Re: Interpretation for SPA 73-C-187-3, Vale United Methodist Church  
Tax Map 36-4 ((1)) 19: Additional Pavement Area, Replacement of Transitional Screening

REF: Vale United Methodist Church  
11528 Vale Road  
Oakton, VA 22124  
Tax Map 36-4 ((1)) 19  
SPA 73-C-187-3  
CCCI Project No. 344.0013

SUBJECT: Interpretation Request – Notice of Violation dated 10/5/04

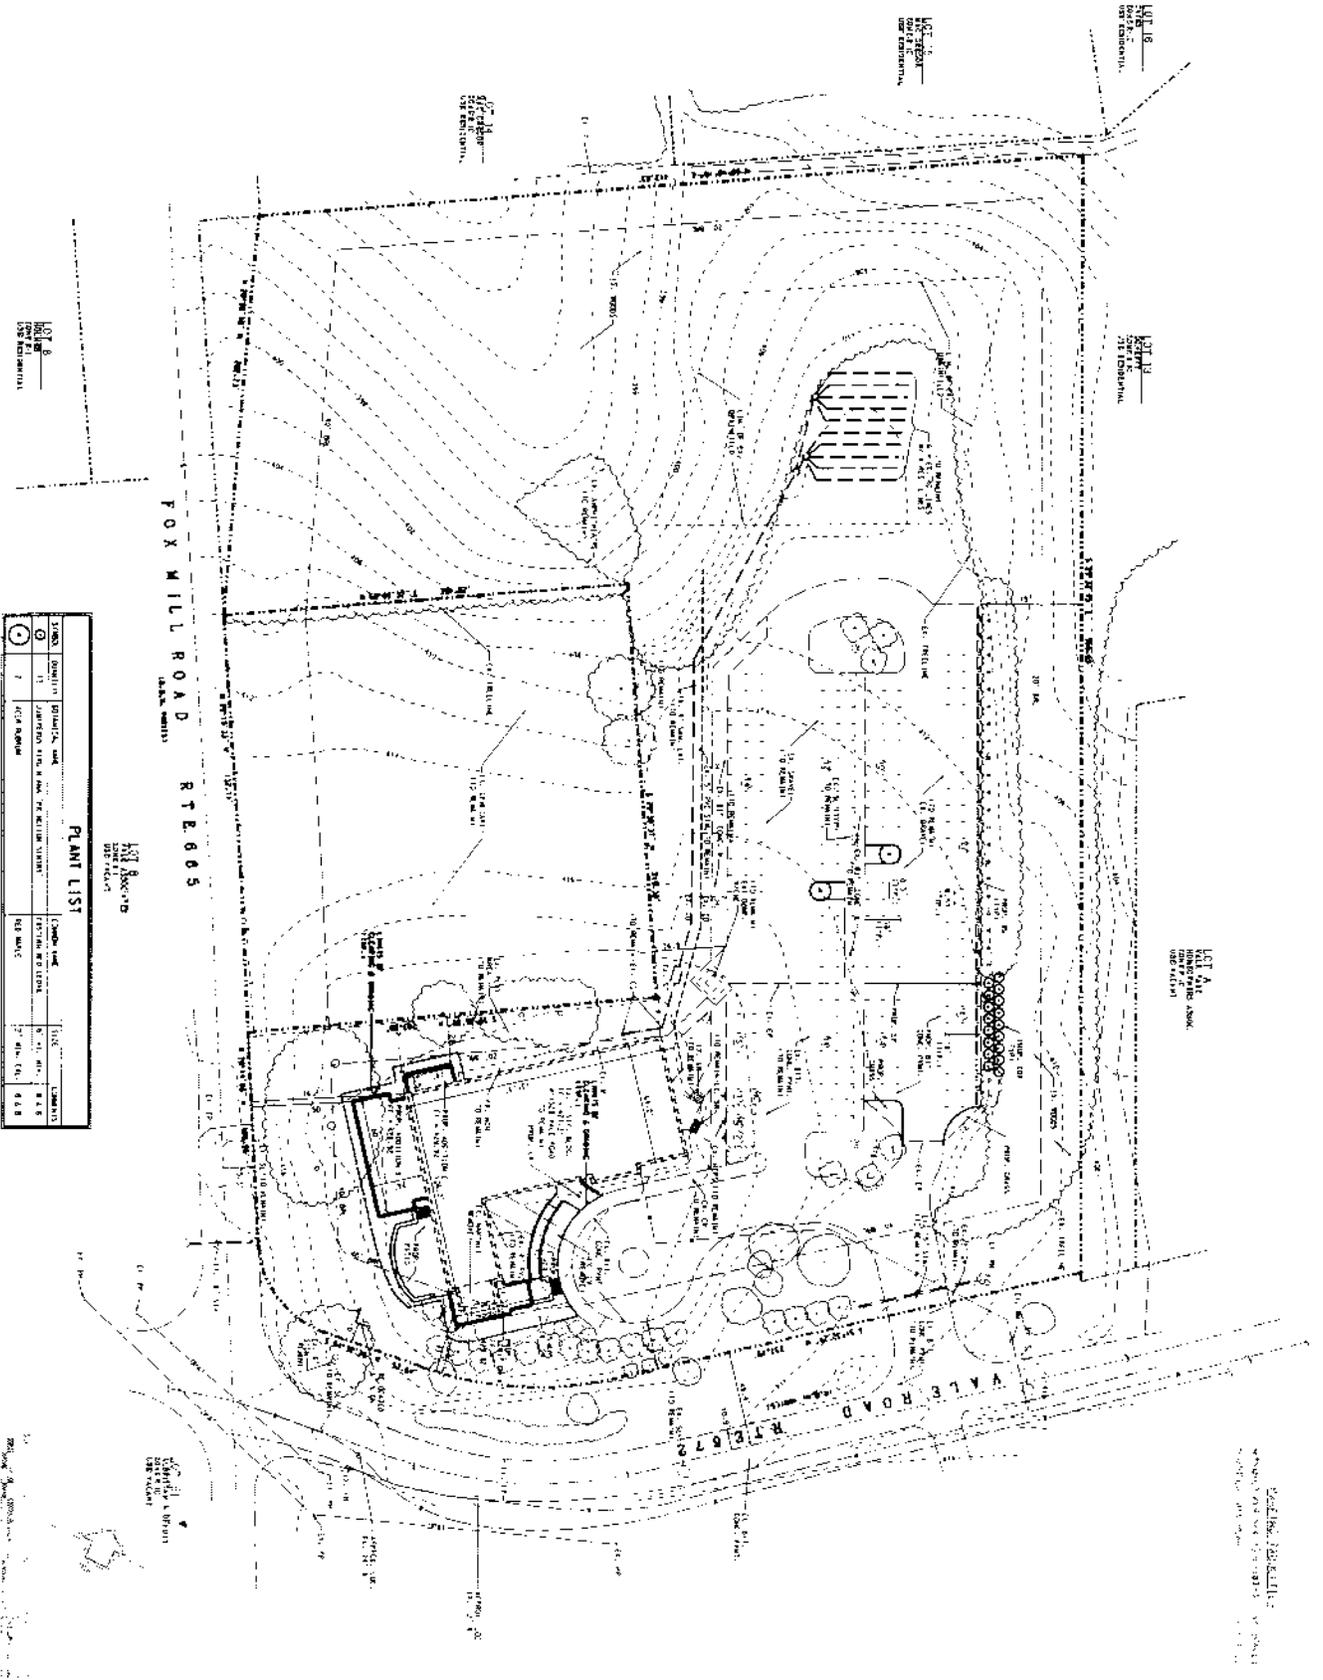
As I understand it, a Notice of Violation has been issued to the Vale United Methodist Church for paving an area of the parking lot that was shown as gravel on the SPA Plat and for the removal of wheel stops that were features of the SPA Plat. You are seeking approval to retain the paved parking area in its current configuration. You have stated that wheel stops will be replaced in accordance with the SPA Plat.

In addition, a number of evergreen trees have been lost adjacent to the parking area. These trees are part of the required transitional screening for the property. You propose to provide seventeen eastern red cedars having a minimum height of six feet as replacement plantings in this area.

You have indicated that no site plan has yet been filed to implement the building additions approved by the BZA with the subject special permit amendment. In response to the Notice of Violation, you have provided stormwater runoff calculations that show an increase in runoff (0.16 CFS) due to the additional paved area of the parking lot. Staff of the Department of Public Works and Environmental Services (DPWES) have indicated that the additional paved area and increase in stormwater runoff will require approval of a site plan or a minor site plan, and the provision of stormwater management measures, or application for a waiver from the Director of DPWES.

You will notice that there is a slight increase in runoff of 0.16 CFS for a 10 year storm, but there is also a slight decrease in actual paved area versus existing gravel area of 300 SF. The runoff sheet flows across the parking lot to the existing woods located to the east of the property. Please note that the net increase in runoff is insignificant and there is no evidence of erosion along the eastern edge of the existing pavement.

The church has agreed to re-install the wheel stops as a condition of complying with the "Notice of Violation" in favor of leaving the existing pavement and also has agreed to replace some of the existing evergreen trees that have been lost to storms along the eastern edge of the parking lot.

We have reviewed the existing site conditions and prepared an "Interpretation Plat" showing the deviations from the previously approved SPA for your information and review of our request. Also attached is copy of the approved SPA.

No other changes to the site from what was approved on the SPA were noted in the field. Even though the church re-striped the parking spaces for 90 degree parking and better site circulation, there is no increase in parking spaces approved on the current SPA.

It is my determination that the additional parking lot pavement, replacement of wheel stops and replacement of evergreen trees along the northeastern boundary would be in substantial conformance with the SPA Plat and the development conditions, provided that a site plan or minor site plan is submitted, as determined by DPWES, stormwater management is provided, as determined by DPWES, and replacement evergreen trees are provided as approved by the Urban Forest Management Branch, DPWES. Please note that a minimum of 97 parking spaces, as shown on the SPA Plat, must also be provided.
